Florence Fabrics Ltd

24 February 2015

Observations

Possible lack of lateral bracing in the Production Building

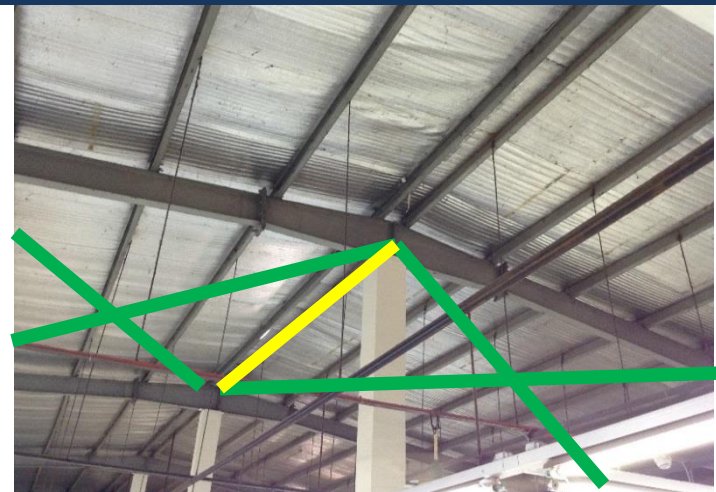
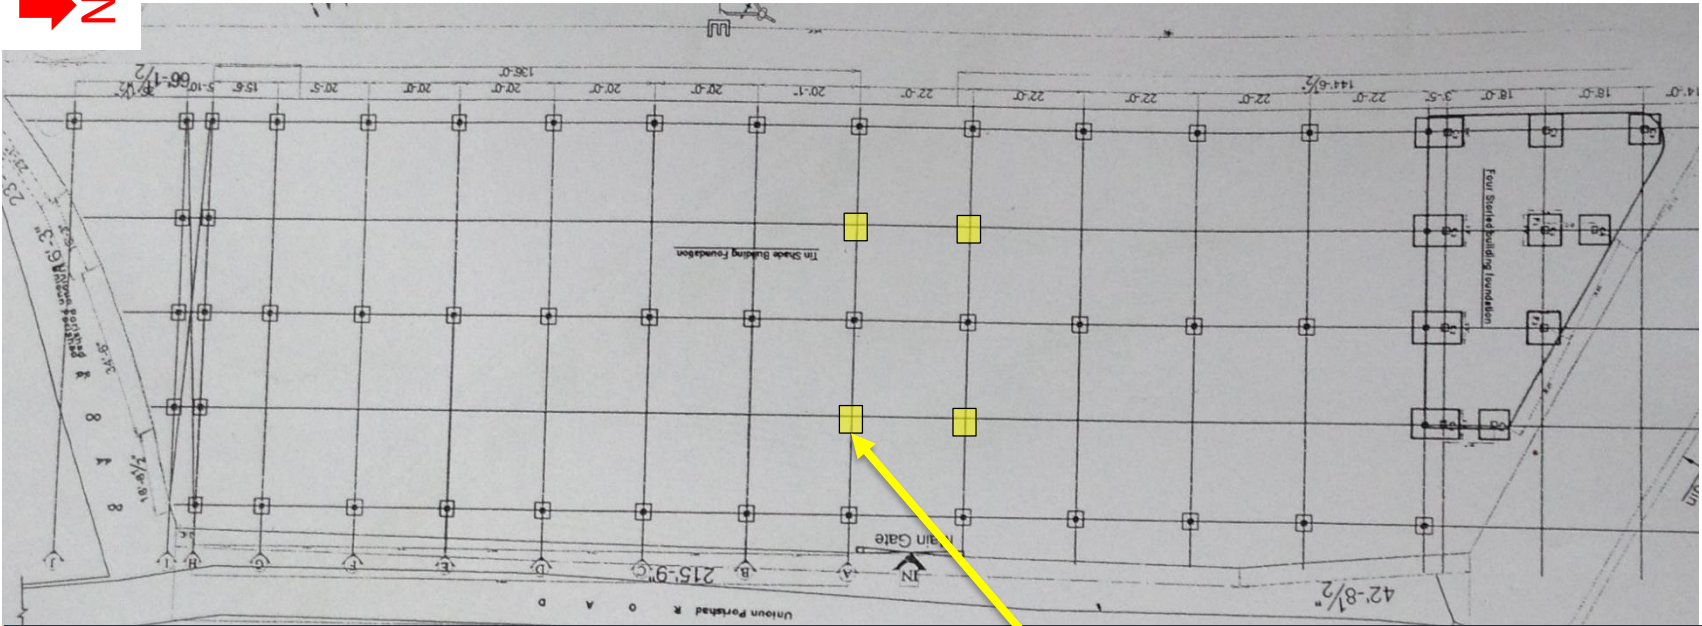
The Production Building doesn't have any obvious lateral bracing. Connection to the Office Building structure to be investigated. The capacity of the concrete columns to provide lateral stability to be investigated.

A possible lateral bracing system is presented in green and yellow if required

Production Building plan and the position of the additional columns

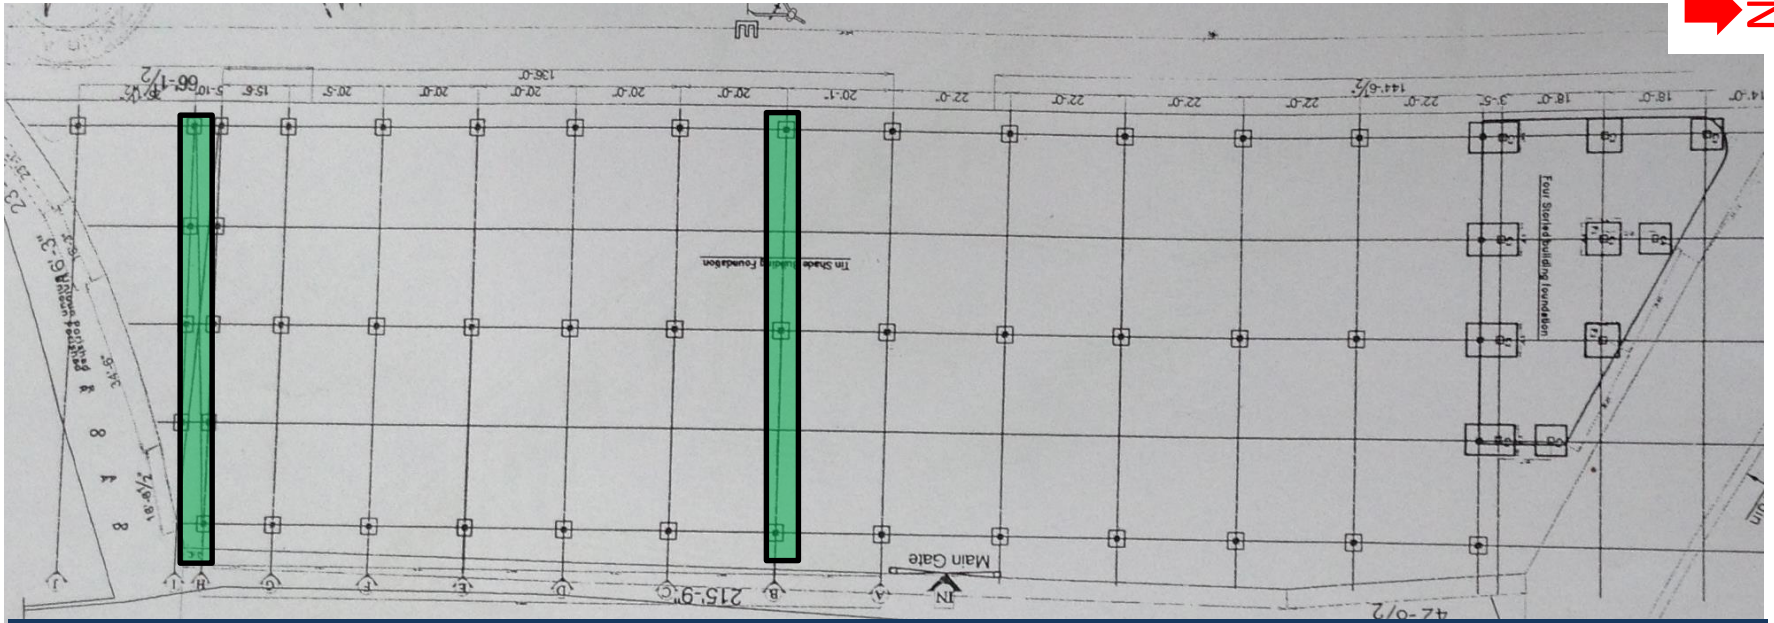
Additional columns were found in the middle of the building but they are not shown on the Structural drawings.

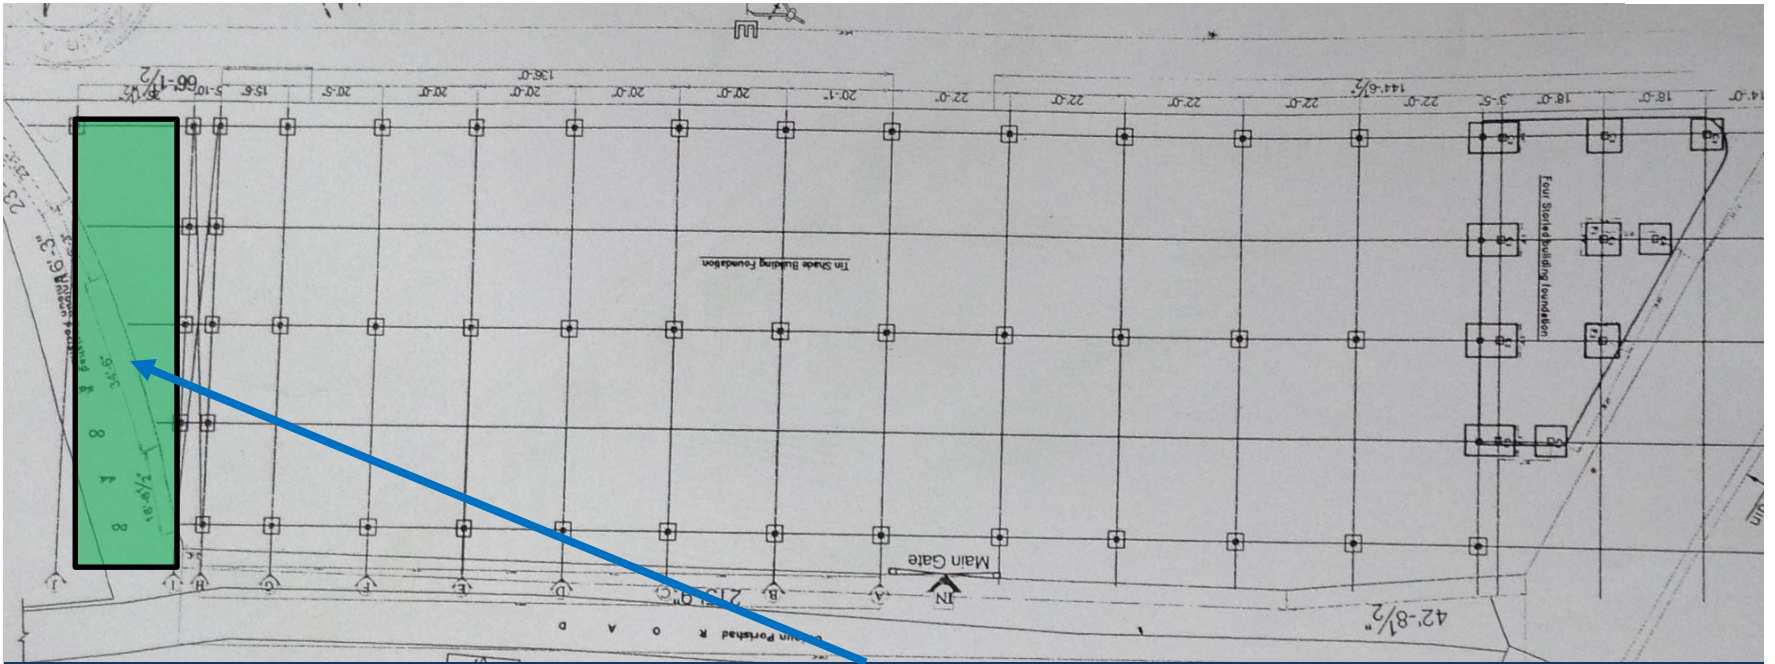
The steel roof frame in 2 grids has a different shape to the typical frame shape. This is not defined in the structural documentation.

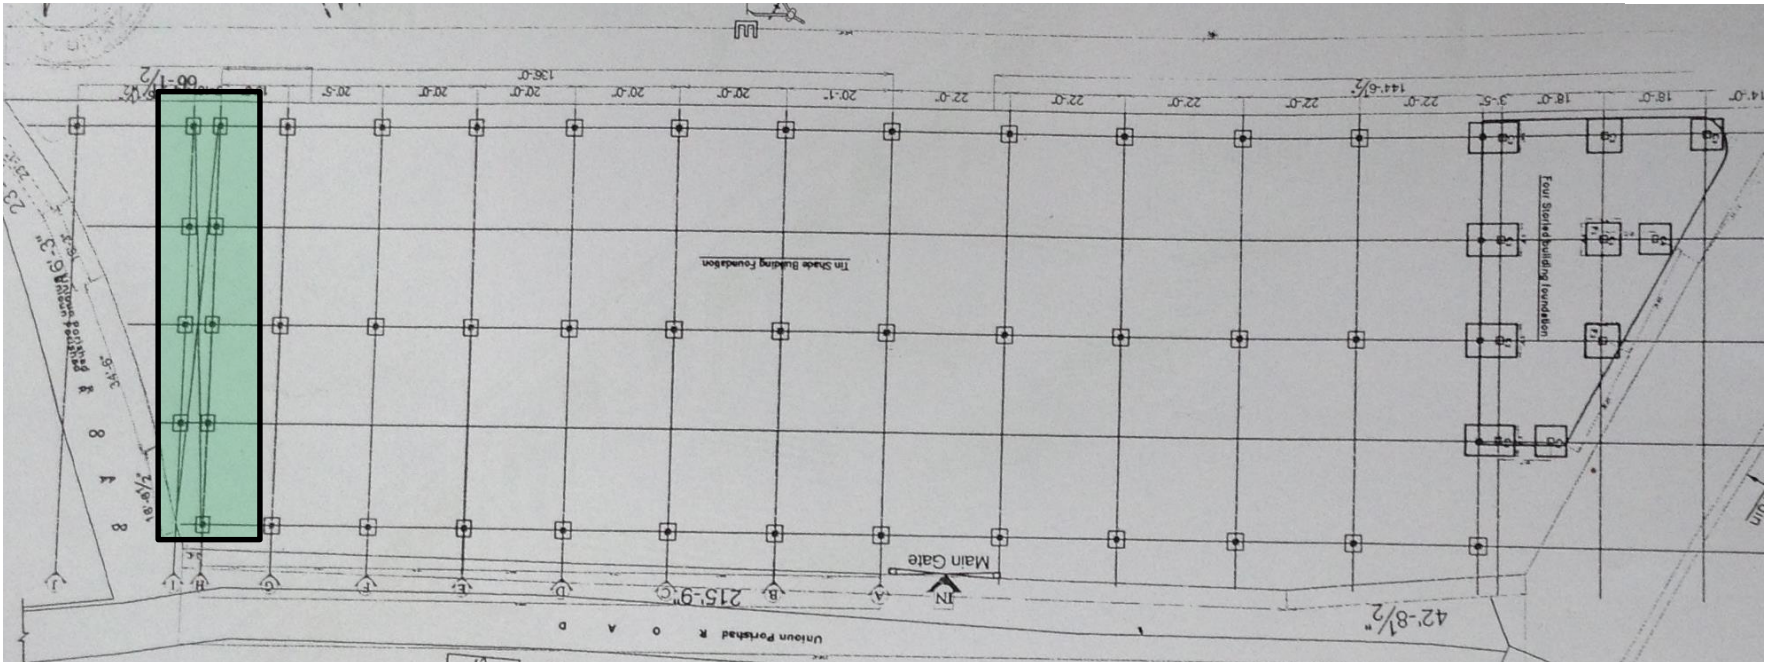
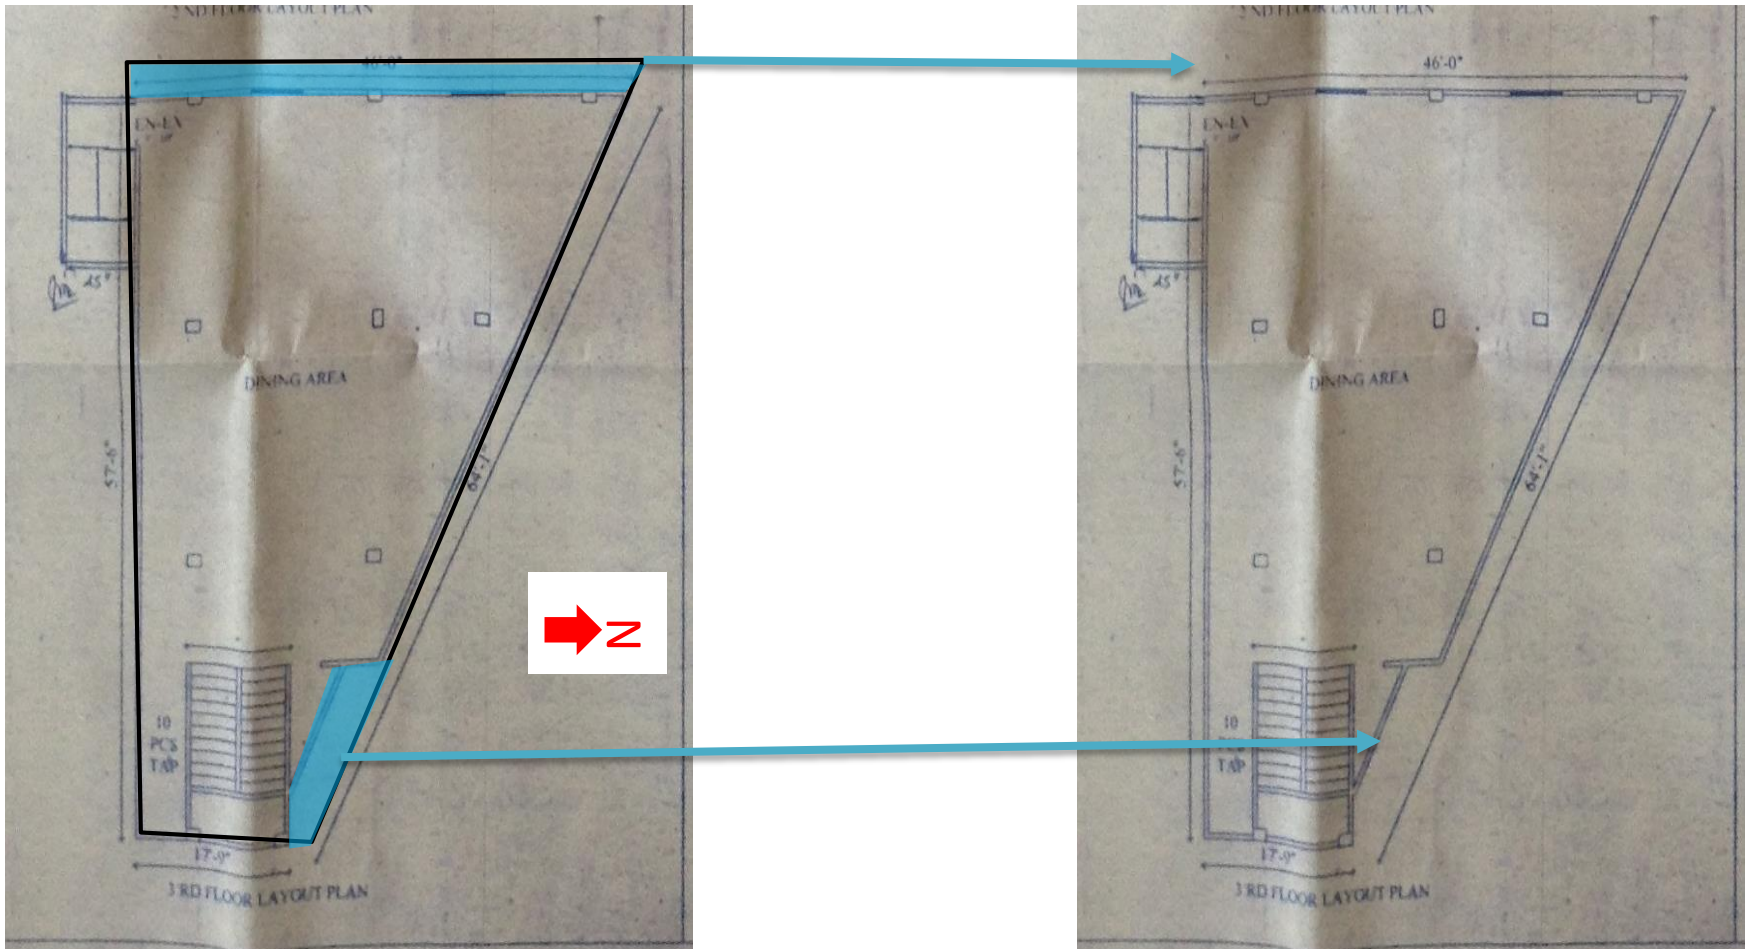
One additional bay was found in the South side of the building.

The proposed lateral bracing between these two grids is not present.

Additional Cantilevers were build beyond those shown on the Office Building permit drawings.

Missing Connection bolts in the Roof steel frame of the Production Building

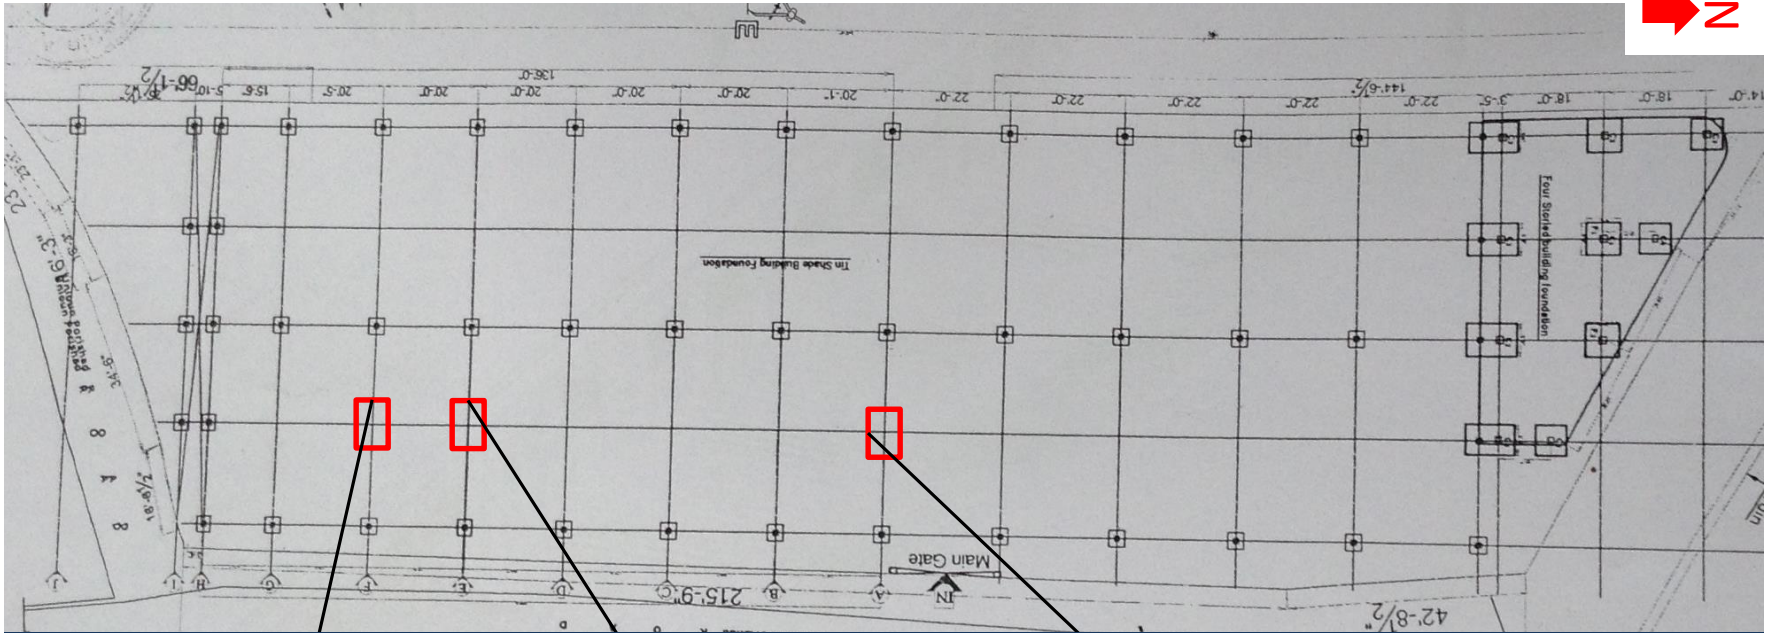
Some connection bolts were missing in the Steel roof frame.

Uncontrolled storage loading and water tank in the Office Building

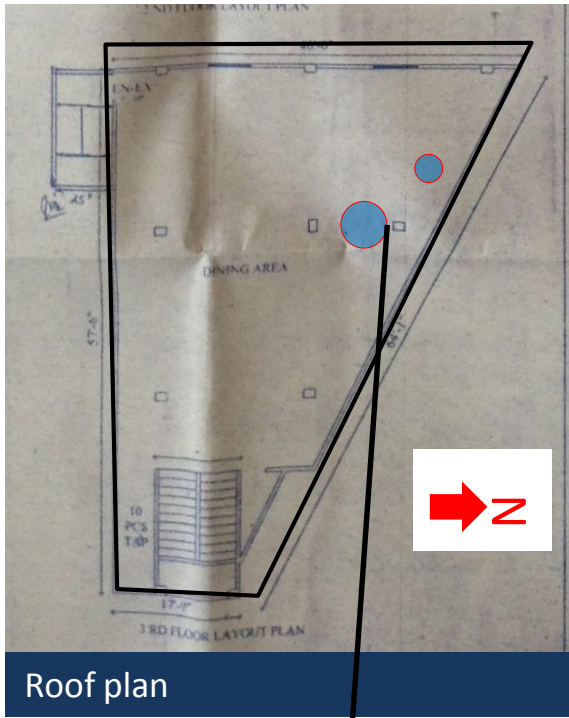
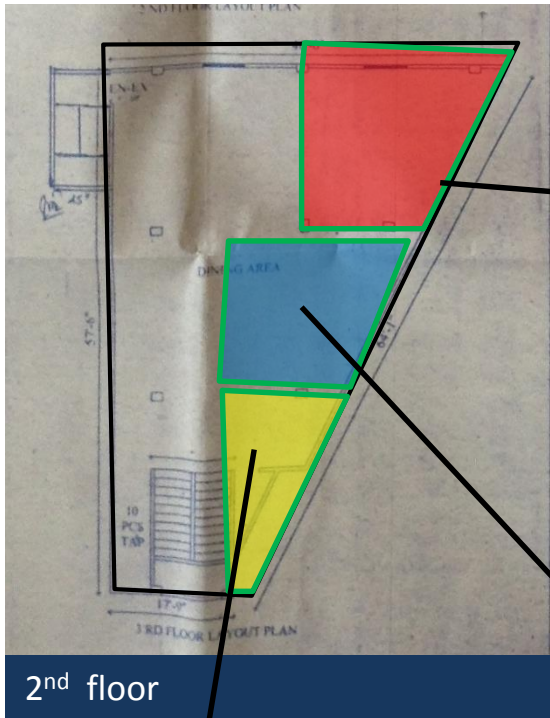
Loose garments storage – 2m height

Water tank

5	Uncontrolled storage loading and water tanks (Office Building)	Building Engineer to confirm design loading on slabs and take appropriate action by removing storage loads where required.	6-months
6	Uncontrolled storage loading and water tanks (Office Building)	Engineer to design a loading plan for the building.	6-months
7	Uncontrolled storage loading and water tanks (Office Building)	Spread the load of the roof water tanks on a bigger area.	6-months

Lateral Stability of the steel stair structure

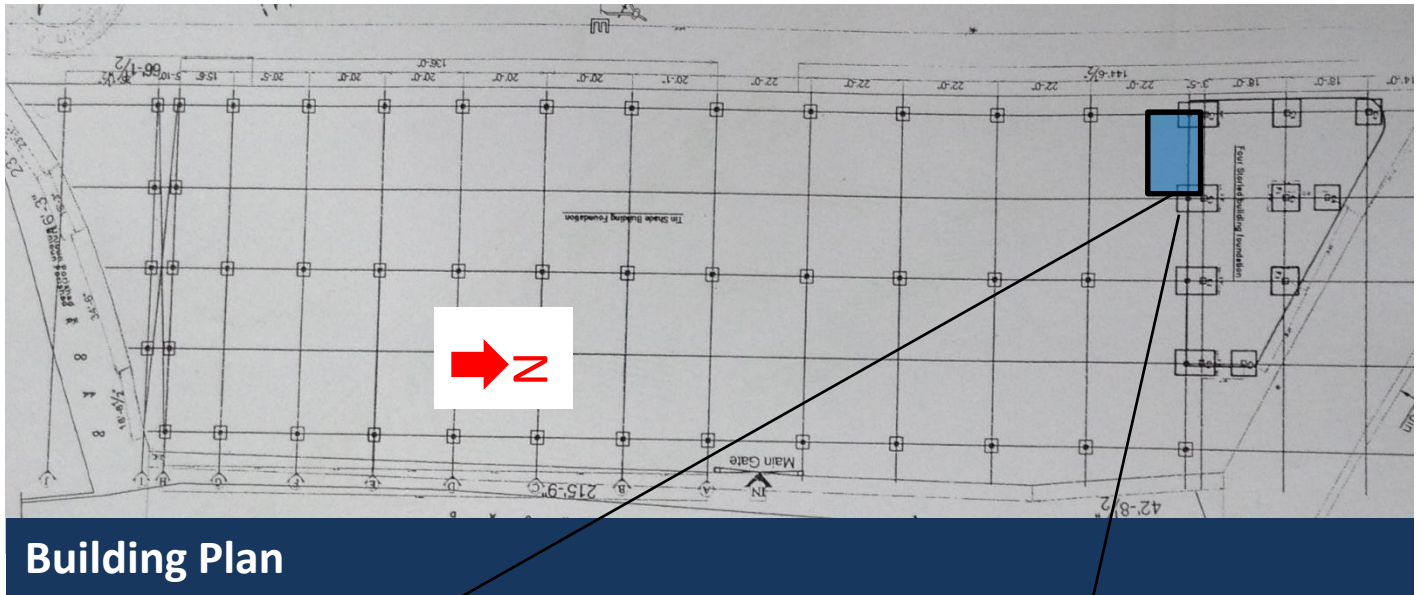
Lightweight steel stairs may not be adequately connected to the load bearing elements of the Office building and there is no lateral bracing.

Item No.	Observation	Recommended Action Plan	Recommended Timeline
8	Lateral Stability of the steel stair structure	Building Engineer to confirm design loading, lateral bracing and the connection to the Office Building.	6-months
9	Lateral Stability of the steel stair structure	Lightweight steel stairs to be reconstructed/upgraded to ensure structural adequacy under code vertical and lateral loads by the Building Engineer.	6-months
10	Apparently non-engineered lightweight roof of the Generator building	Lightweight steel roof are to be reconstructed/upgraded to ensure structural adequacy under code vertical and lateral loads by the Building Engineer.	6-months

Apparently non-engineered roof structure of the Generator building

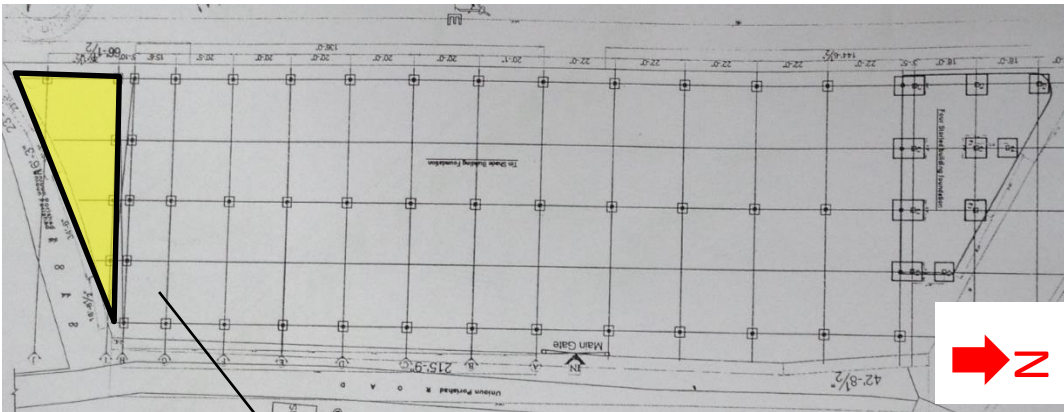
The Generator Building has an apparently non-engineered light weight steel roof structure. The roof frames appear to be supported on brick walls. The brick walls show some cracking under the connection point loads.
